March 31, 2005

Subject: Former Exxon RAS #7-3399, 2991 Hopyard Road, Pleasanton, California,
ACHCSA File No. RO-362

**Soil and Water Investigation Work Plan and
Modified Corrective Action Plan**

**Former Exxon Retail Site 7-3399
2991 Hopyard Road
Pleasanton, California**

FIGURE 2: FORMER EXXON RETAIL SITE 7-3399
MW1: Groundwater Elevation with Analytical Concentration Trends

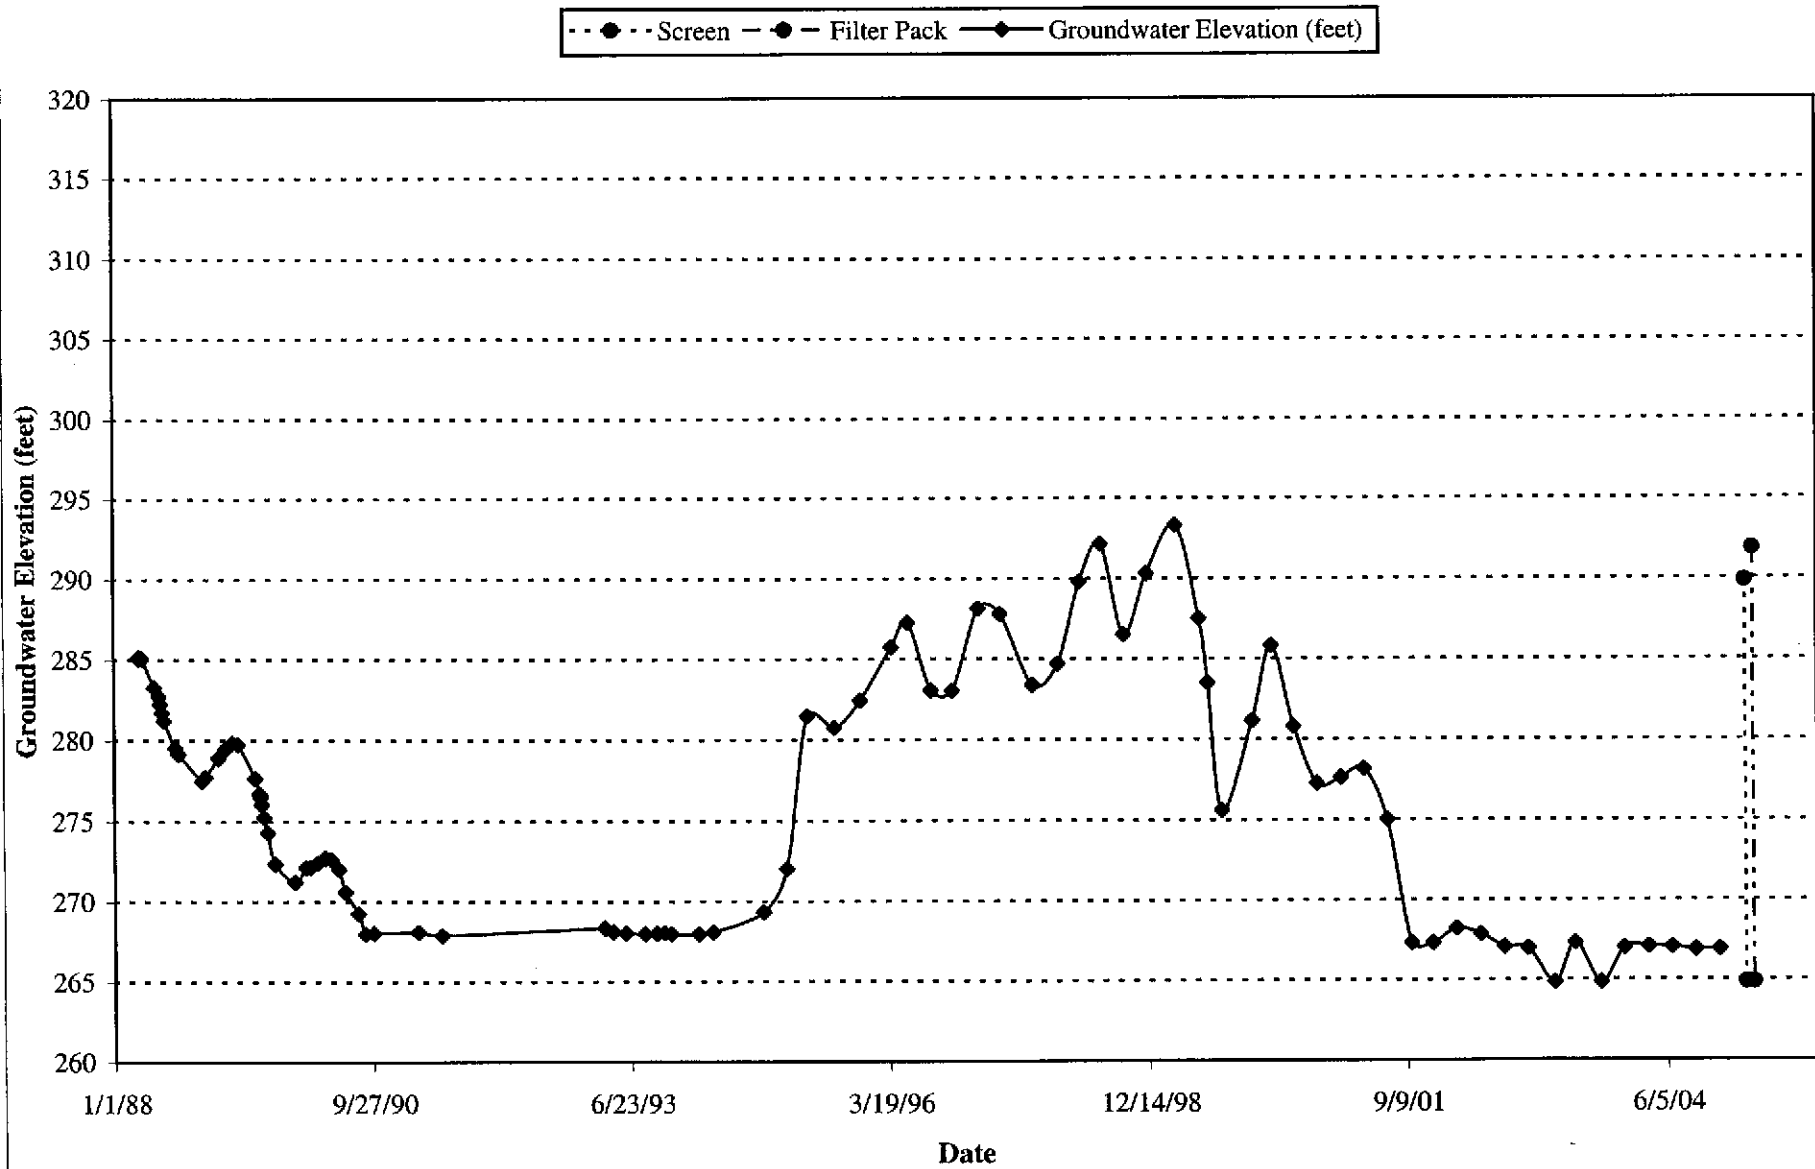
4. The ACHCSA letter reiterates the statement in the Proposed Shutdown of Groundwater Extraction System letter (ETIC 2004b) that the extent and concentrations of hydrocarbons and MTBE are stable or decreasing across the site. The letter further states that the inefficiency of the GES may be largely the result of decreasing groundwater levels and requests a series of isoconcentration maps showing current concentrations in each of the water-bearing zones.

The groundwater extraction wells are screened within the perched zone (including tank backfill wells) and within Zone 1 at the site. Groundwater within the perched zone is only intermittently available for sampling and is currently inadequate for the operation of the system. Groundwater levels in Zone 1 have shown a significant decrease since 2001. Since static groundwater currently occurs at the site in Zone 1 at a depth of approximately 55 feet below ground surface (bgs) and the clay layer which constitutes the bottom of Zone 1 occurs at approximately 57 feet, there is only approximately 2 feet of water within Zone 1, which is inadequate for the operation of the system. To illustrate this point, a hydrograph of MW1, which is located within Zone 1, is provided as Figure 2.

The current concentrations and maximum concentrations for the past four quarters of benzene, Total Petroleum Hydrocarbons as gasoline (TPH-g), and MTBE in micrograms per liter ($\mu\text{g/L}$) are shown below:

As shown in the table above, MTBE and hydrocarbon concentrations are low and appear to be decreasing at the site. The current MTBE and hydrocarbon concentrations for each zone are shown in Figure 1. Since benzene was not detected and since well VR1 is the only well with detectable concentrations of TPH-g and MTBE, isoconcentration maps were not prepared.
